UNITED STATES PATENT AND TRADEMARK OFFICE

APPLICATION NO.	FILING DATE	FIRST NAMED INVENTOR	ATTORNEY DOCKET NO.	CONFIRMATION NO.
10/622,446	07/21/2003	Gregory Tuc	116640	5233
25944	7590	04/27/2005	EXAMINER	
OLIFF & BERRIDGE, PLC P.O. BOX 19928 ALEXANDRIA, VA 22320			FERGUSON, MICHAEL P	
		ART UNIT	PAPER NUMBER	
		3679

Office Action Summary	Application No.	Applicant(s)	
	10/622,446	TUC ET AL.	
	Examiner	Art Unit	
	Michael P. Ferguson	3679

DETAILED ACTION

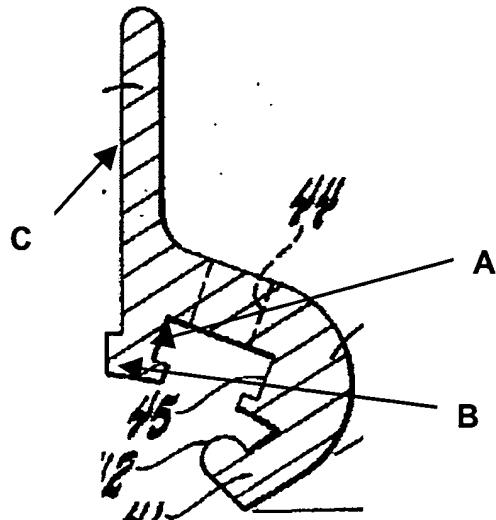
a fixing tab **33,42** suitable for engaging in a slot **29** of the tubular element;
an opening allowing a screw shank **52** to pass through for holding the panel; and
a face **C** for pressing against one side of the panel and comprising stiffening ribs **32,34,A,B** (Figure 6 reprinted below with annotations; Figures 5-7).
